Commonwealth Edison Company

SUBJECT: LICENSE DPR-19, DRESDEN NUCLEAR POWER STATION - UNIT #2

DESIGN MODIFICATION

FIG. 1

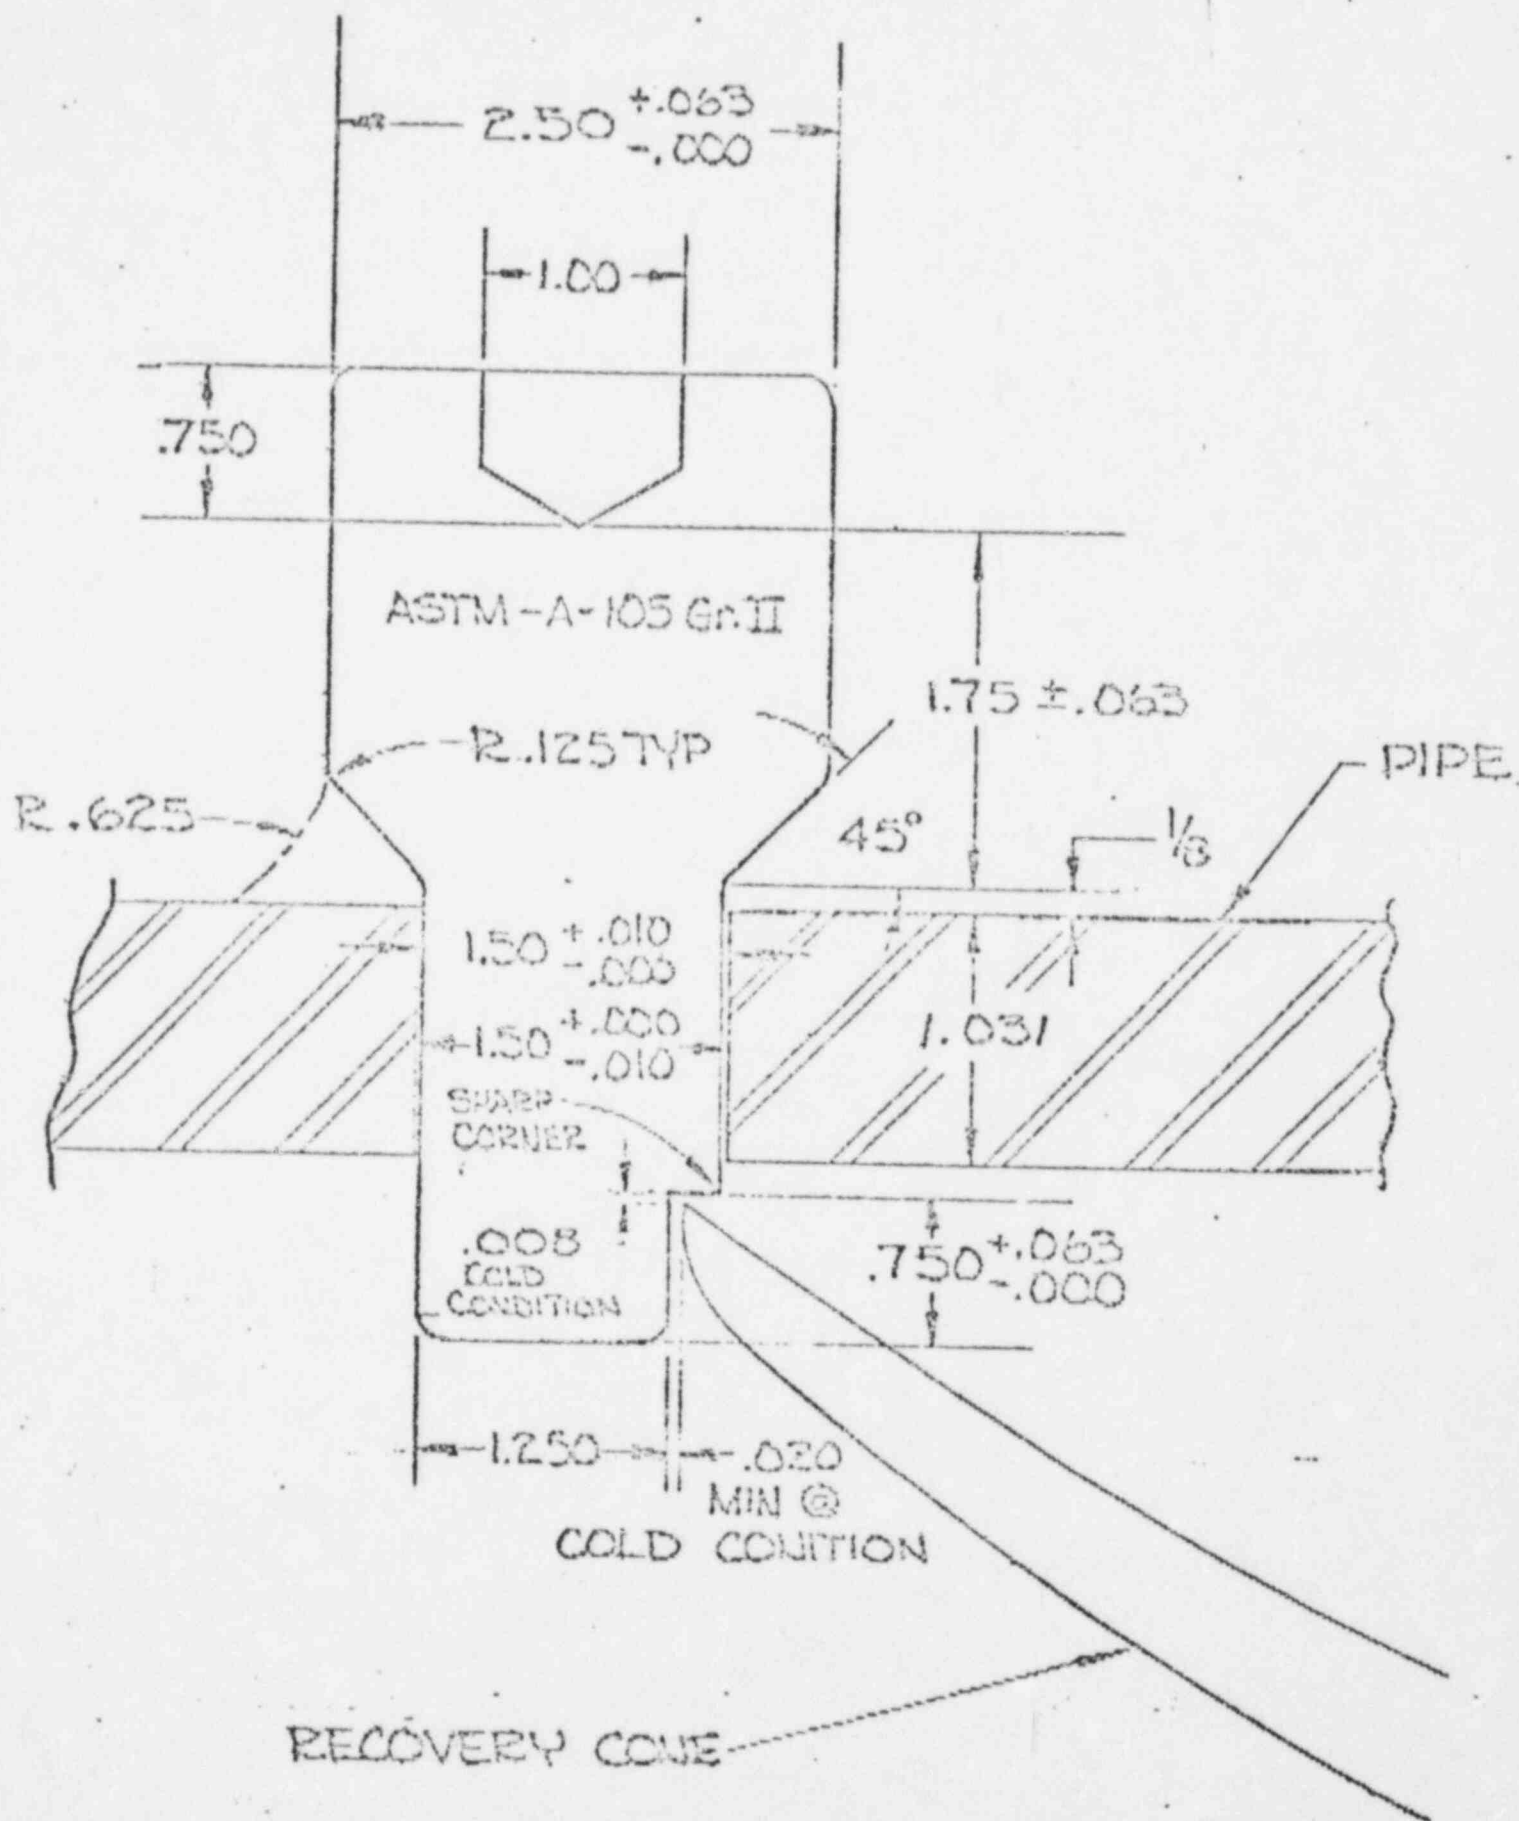
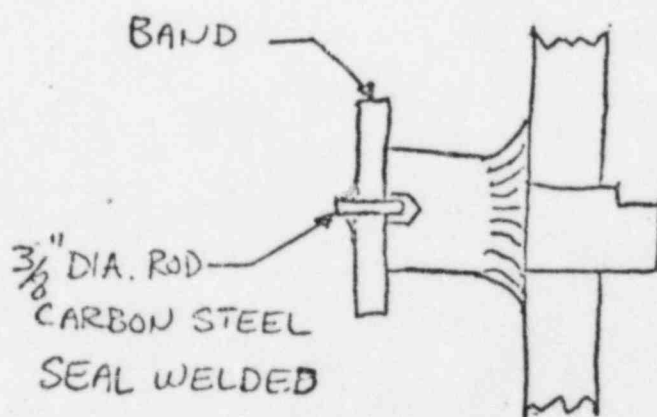
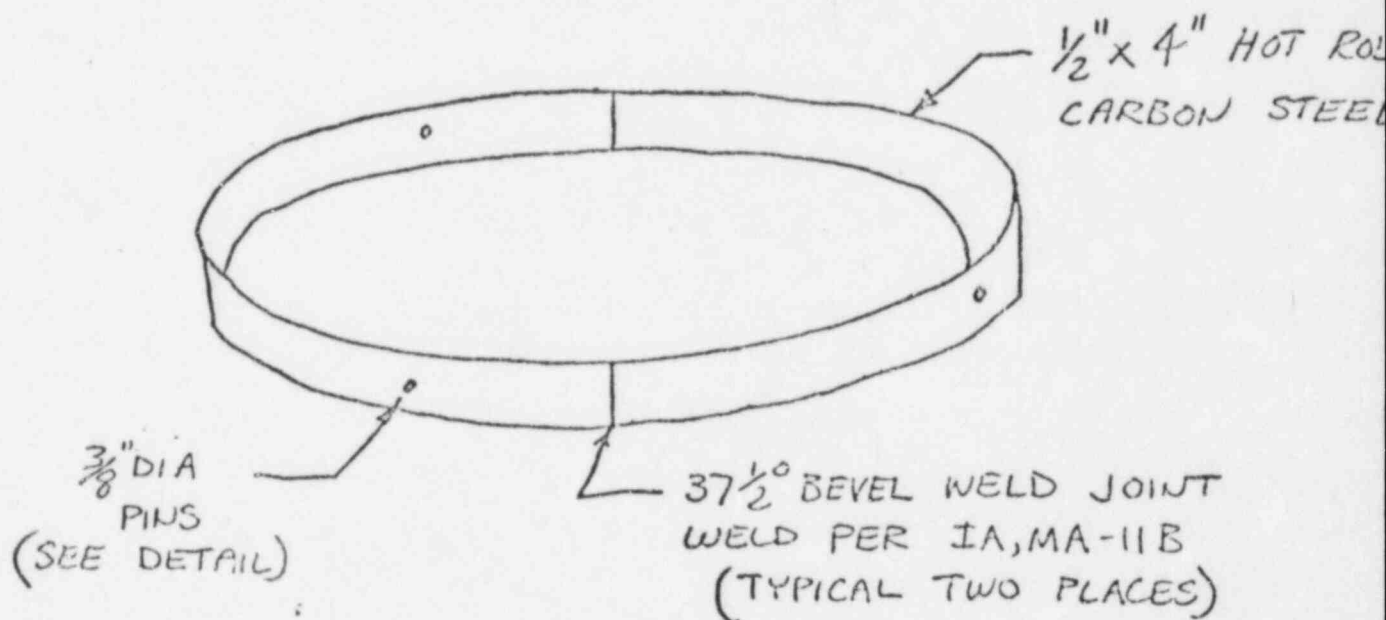
1. The Dresden II main steam flow element is modified by installing three (3) pins at 120° apart downstream of the recovery cone, with a clearance of .020" minimum to take care of the differential thermal expansion between pipe (carbon steel) and flow element cone (stainless steel) as shown on Figure 1, attached. Based on the assumption that the throat-to-recovery-cone weld on the A, C & D lines fail these pins are designed to prevent the recovery cones from moving down stream into the MSIV. These pins will also prevent any vibration of the downstream recovery cone that may exist during operation. Stress analyses show that if the downstream cone should fail and be held by only one pin, the pin shear stress will be 13,866 psi if 100 psid exists across the restrictor. This assumption is very conservative because normal operating differential is approximately half of this. The allowable stress for this emergency condition is 90% of yield strength, or 27,800 psi (Note: $S_m = 18,600$). Since the maximum stress with only one pin carrying the load is 13,866 psi, the design of the pins is more than adequate.

Area replacement was also considered in designing these pins, based on ASME-Section III, 1971, Paragraph NE-3643.3 - Reinforcement for Openings.

$$\text{Area removed} = 1.389 \text{ in}^2 \quad / \quad \text{Area Available} = 1.688 \text{ in}^2$$

Combined stress in $1\frac{1}{2}$ " pin weld is 9,259 psi. Includes pressure and temperature stress plus the stress due the cone resting on one pin. Allowable stress is 18,600 psi.

A retaining clamp, or "belly band", has been installed around these pins as indicated on Figure 1A attached. Because the pins are not threaded into the pipe, this was added to prevent expulsion of the pins in the unlikely event that the welds were to fail.
